Our Ref: 16083-LE130720
Contact: Matt Cooper

**RE: SECTION 75W MODIFICATION – MP06_0143_MOD4
THE GLADES ESTATE, MOONEE BEACH**

Appendix A – Response to DPE Matters

Project **THE GLADES ESTATE - BULK EARTHWORKS**
 Title **SECTIONS PLAN**
LOT 1 DP 725785
PACIFIC HIGHWAY - MOONEE BEACH

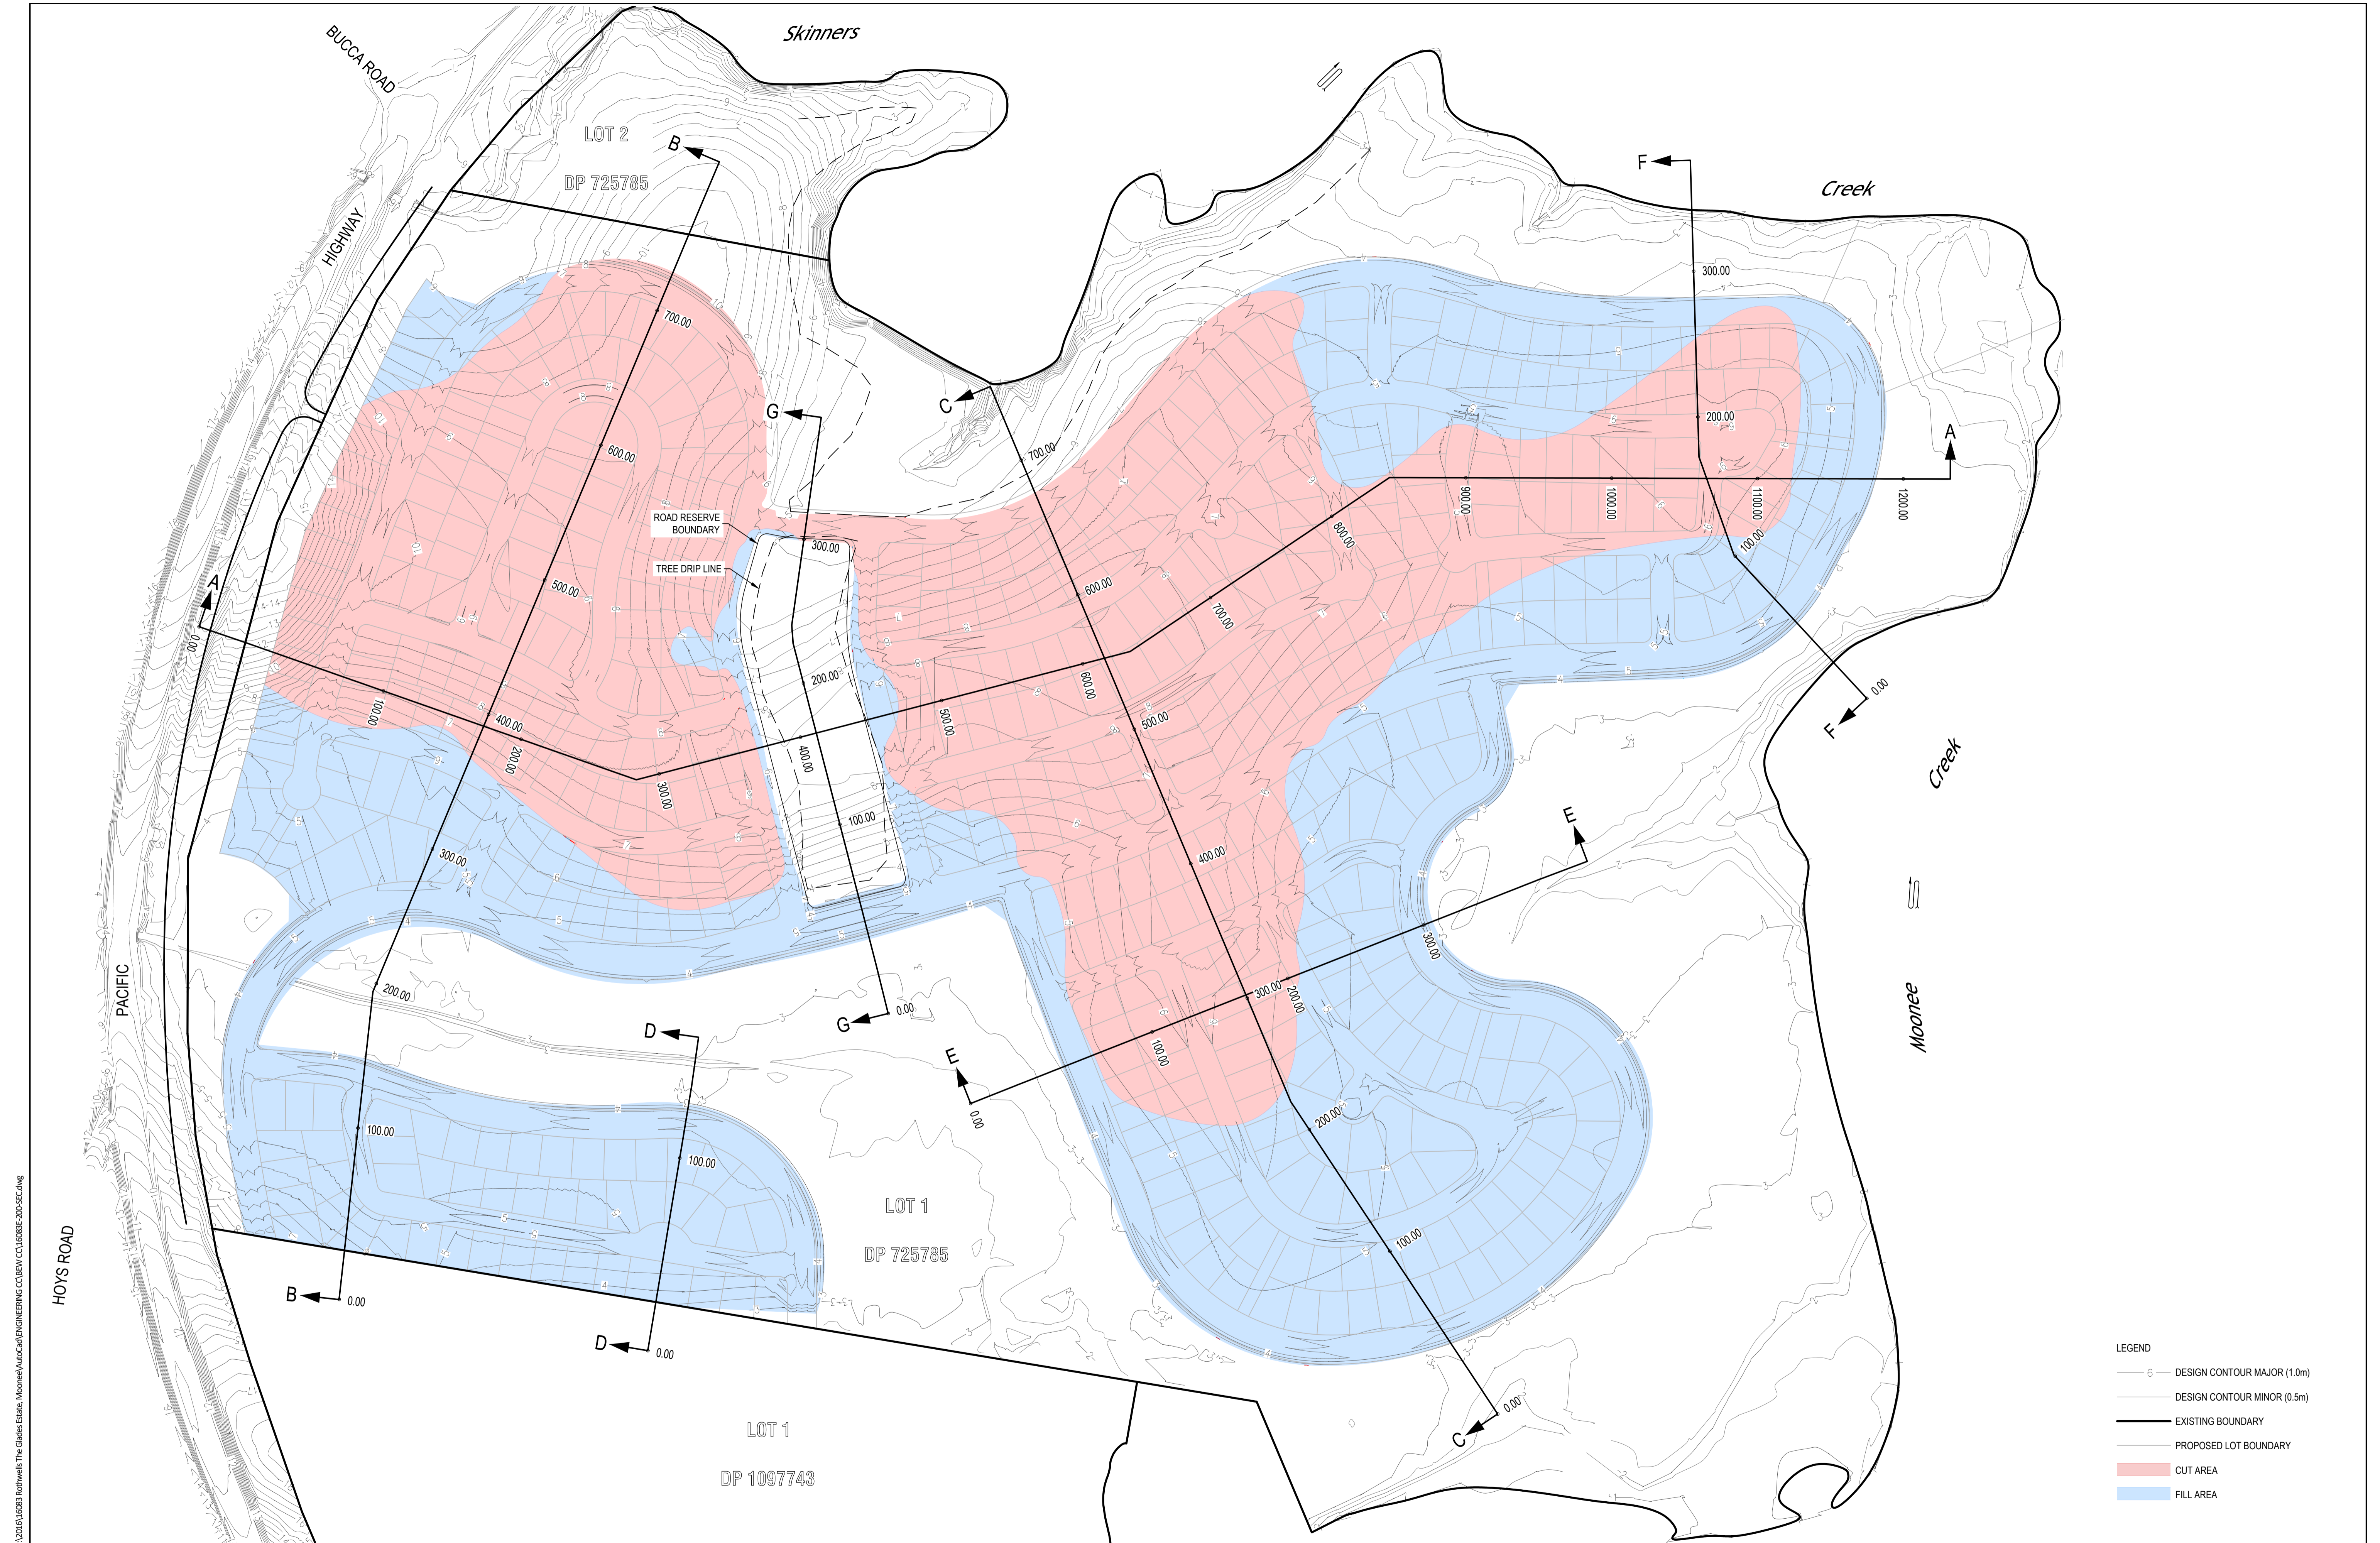
Correspondent	Issues Raised	RDM’s Response
<p>Department of Planning, Industry & Environment (DPIE) (Email 170720)</p>	<p><u>Proposed deletion of condition D6.2 and second sentence of condition E16:</u></p> <ul style="list-style-type: none"> ▪ <i>It is noted in the original assessment report that the reference to fill platforms in southern open space areas were included as part of conditions D6.2 and E16, to mitigate potential impacts on the groundwater table.</i> 	<ul style="list-style-type: none"> ▪ Condition D6(2) states: <i>“Fill platforms must be set at a minimum of 2 metres above the 1 in 100 year flood level or the water table (whichever is the higher) in the southern open space areas that contain stormwater infrastructure, in accordance with the Auspacific Engineers advice dated 4 April 2008.”</i> <p>Condition E16 states:</p> <p><i>“Prior to the release of a Subdivision Certificate for the first state of the project to be released a final contour plan shall be submitted to Council showing the location, depth and type of fill located on the site. This shall include fill platforms of minimum of 2 metres above the 1 in 100 year flood level or the water table (whichever is the higher) in the southern open space areas that contain stormwater infrastructure, in accordance with Auspacific Engineers advice dated 8 April 2008.”</i></p> <p>Section 6.9 of the Departments Assessment Report (dated February 2009) refers to Auspacific Engineers report concerning the existing water table and fill platforms.</p> <p>An extract from Auspacifics advice (dated 4 April 2008) concerning bulk earthworks and the placement of fill in parts of the site that are subject to “high water table” is repeated as follows:</p>

Title **LONGITUDINAL SECTION - A**
LOT 1 DP 725785
PACIFIC HIGHWAY - MOONEE BEACH

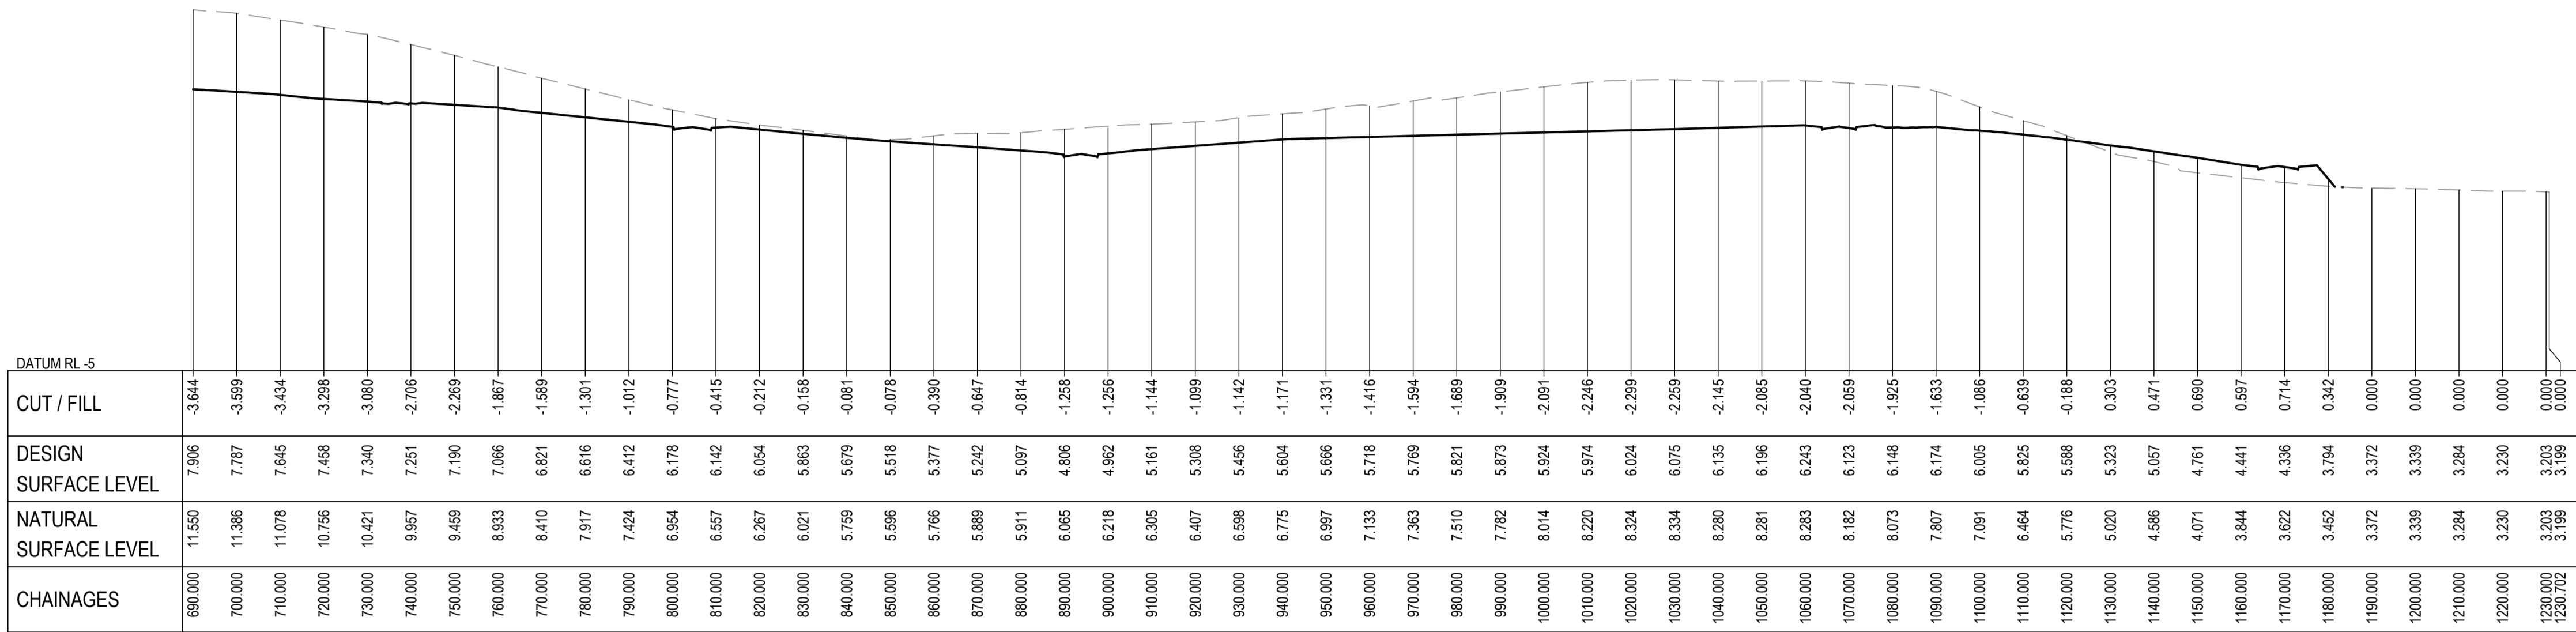
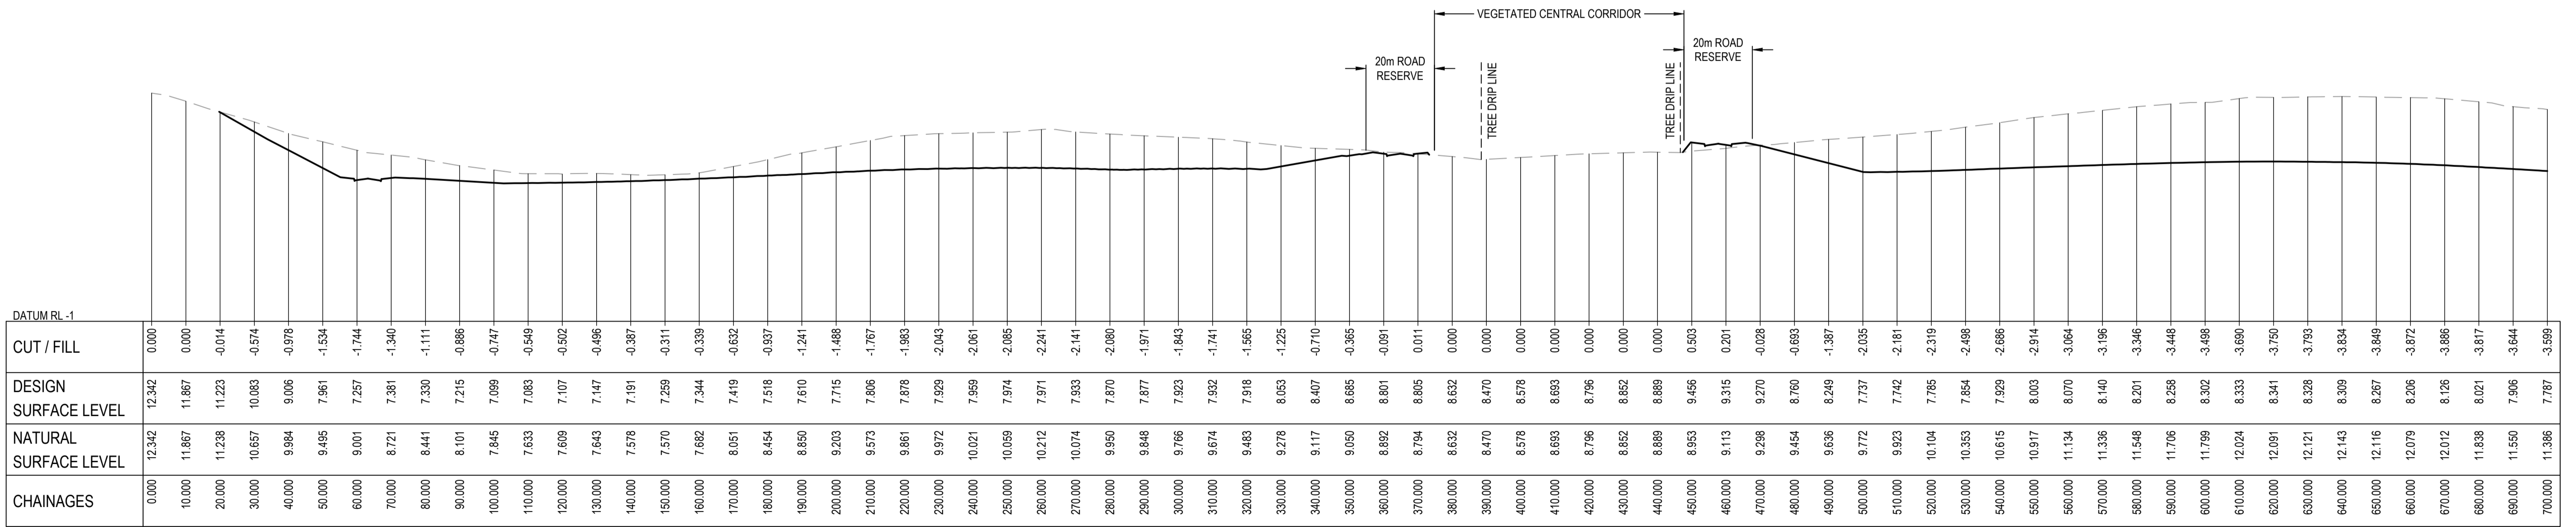
Correspondent	Issues Raised	RDM's Response
		<p>infrastructure have not changed since Council's assessment referred to in their letter dated the 20th of June 2016.</p> <p><i>Note: Council's letter 20th of June 2016, should in fact be 20th of June 2019.</i></p>
	<p><u>Earthworks in vicinity of the vegetation corridor:</u></p> <ul style="list-style-type: none"> ▪ <i>Based on the information provided, it is our understanding that levels around the corridor appear to align with the existing topography on the site, except along the southern corridor boundary.</i> ▪ <i>On this basis, it is requested that further clarity is provided in relation to the corridor and how it will be integrated into the surrounding landscape.</i> 	<ul style="list-style-type: none"> ▪ The attached drawings show longitudinal sections through the site, demonstrating that the roads surrounding the central vegetated corridor generally match the existing ground levels within the vegetated corridor, that is, apart from the southern edge of the vegetated corridor. <p>The proposed road level along the southern edge of the vegetated corridor is however consistent with the fill level of 4.75m required by Condition D6(1) MP06_0143 dated the 5th of March 2009.</p> <p>Notably, longitudinal Section G, (Plan Reference 16083-E-CC204) shows the revised road levels at this location to be 5m (approx.) which is approximately 0.25m higher than what is required by current Condition D6(1). This minor height difference is necessary to satisfy Council's road and drainage design standards.</p> <ul style="list-style-type: none"> ▪ Please refer to RDM's Bulk Earthworks Plans 16083E-CC200 to 16083E-CC204. <p>Please note that CC201 & CC204 include Longitudinal Sections A & G which show the position of the internal road reserve surrounding</p>

Correspondent	Issues Raised	RDM’s Response
	<ul style="list-style-type: none"> ▪ <i>An indicative plan demonstrating cross sections would assist to outline how the land will undulate and integrate into the proposed surrounding levels and proposed mitigation or management of any identified impacts, such as stormwater runoff (if applicable).</i> ▪ <i>Similarly, an indication of the potential impacts on the structural root zones of existing vegetation identified for retention within the corridor would be appreciated and if there is any required mitigation (if applicable).</i> 	<p>the vegetated corridor along with the existing and proposed bulk earthworks levels at their interface.</p> <p>As demonstrated on each Longitudinal Section, the bulk earthworks levels at the road reserve/vegetated corridor interface for the western, northern and eastern alignments coincide with the natural ground level at that location. The bulk earthworks level for the southern alignment remains consistent with the bulk earthworks level approved under MP06-0143.</p> <ul style="list-style-type: none"> ▪ With regard to the stormwater runoff at the northern and southern ends of the vegetated corridor, this will be conveyed under the proposed road through suitably designed culverts. This arrangement is consistent with the approved stormwater strategy and in accordance with Council’s requirements ▪ RDM’s Bulk Earthworks Plans (attached as 16083E-CC200 to 16083E-CC204) shows the interface between the central vegetation corridor and the road reserve boundary. Please refer to Longitudinal Section A & G. <p>With regard to 16083 E-CC200, the drip line of the existing vegetation is also shown relative to the approved road reserve.</p> <p>With reference to the above:-</p> <ul style="list-style-type: none"> a) Any impact to existing vegetation (structural root zones) at the southern interface will be
